# **Pentium® Pro Processor Specification Update**

Release Date: May 1998

Order Number: 242689-028

The Pentium® Pro processor may contain design defects or errors known as errata which may cause the product to deviate from published specifications. Current characterized errata are documented in this Specification Update.

## 2. *Change in PICD[1:0] Hold Time and Valid Delay*

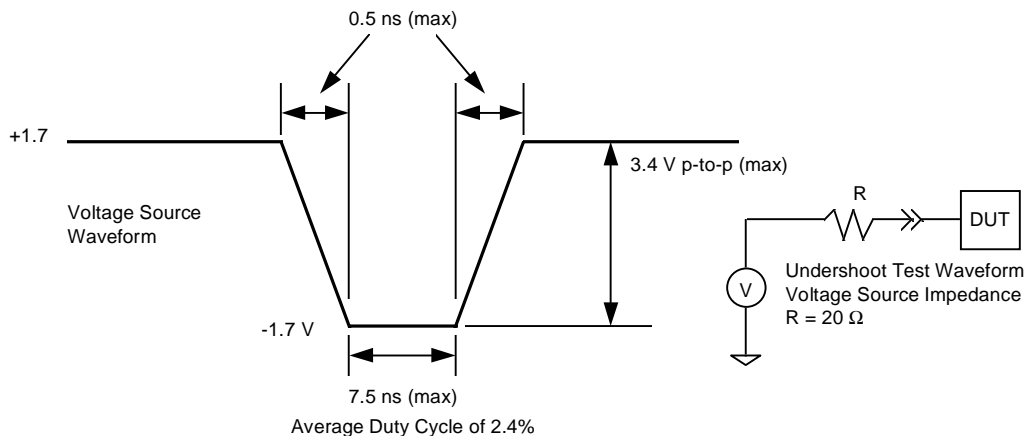
The minimum value of the hold time for the PICD[1:0] signals, T28, will be changed from 2 ns to 2.5 ns. The minimum value of the valid delay for these signals, T29, will be changed from 2.1 ns to 2.0 ns. These values change those documented in Table 11-15 of the *Pentium® Pro Family Developer’s Manual, Volume 1: Specifications*, and Table 15 of the *Pentium® Pro Processor with 1 MB L2 Cache at 200 MHz* datasheet.

*B. Expected Response*

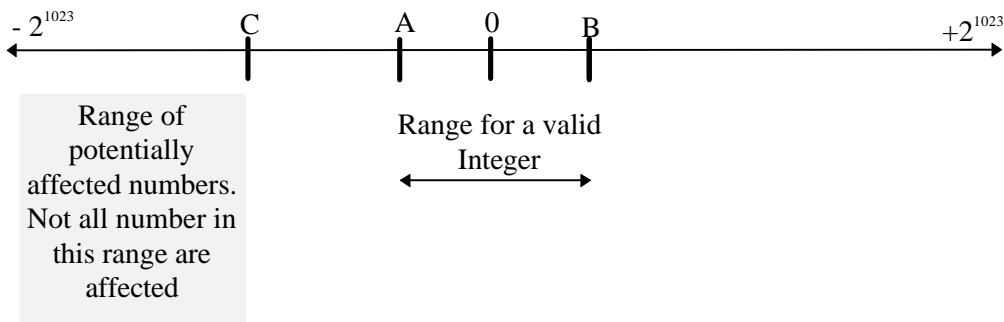
**PROBLEM:** On certain, large, negative, floating-point operands, and only in three of the four possible processor rounding modes, the instructions FIST[P] m16int and FIST[P] m32int do not detect that the operand is so large that it will not fit into the target data size. As a consequence, the expected Invalid Operation exception response for this situation is not correctly provided, nor is the Invalid Operation flag set in the Floating-Point status word as specified in the *Intel Architecture Programmers Reference Manual, Volume 2*. Under the failing conditions, noted below, the precision exception (#PE) flag will also be incorrectly set. The erratum occurs only when all of the following conditions are met:

The expected processor response when the invalid operation exception is *masked* is:

- Return the MAXNEG value (8000h for FIST16 & 80000000h for FIST32) to memory.
- The IE (Invalid Operation) bit in the Floating-Point status word is *set* to flag the overflow.
- The PE (precision error) bit the Floating-Point status word is *not set*.

**Figure 4-3. Stack Switch on a Call to a Different Privilege Level**

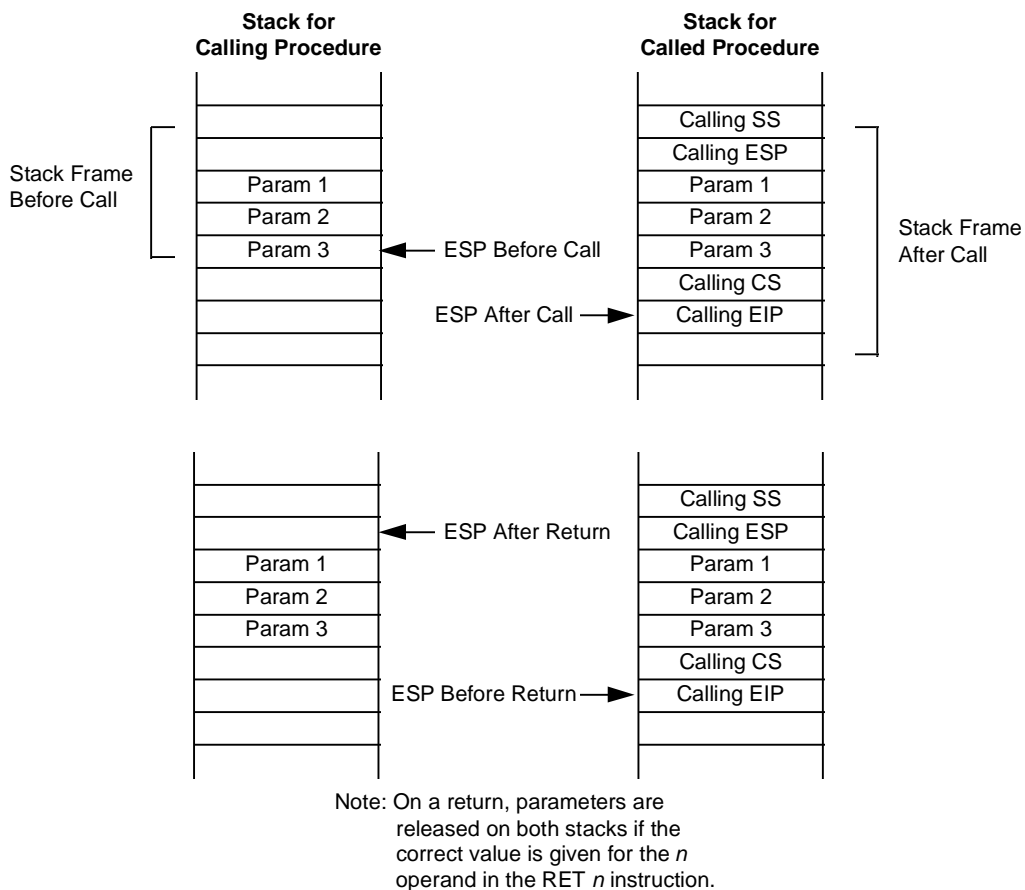
When making a call to a more privileged protection level, the processor does the following (see Figure 4-3):

**Figure 4-4. Stack Usage on Transfers to Interrupt and Exception Handling Routines**

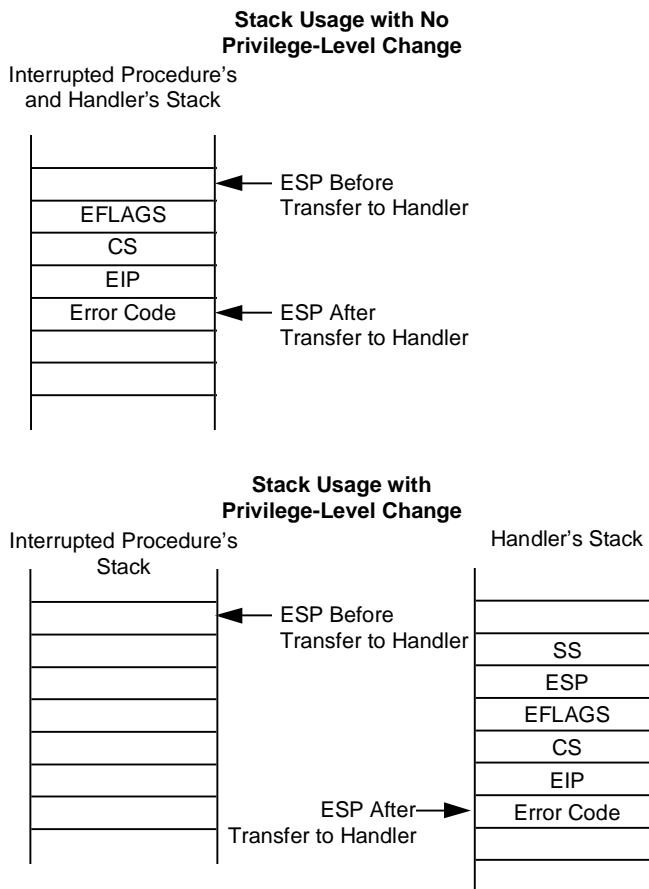
If no stack switch occurs, the processor does the following when calling an interrupt or exception handler (see Figure 44):
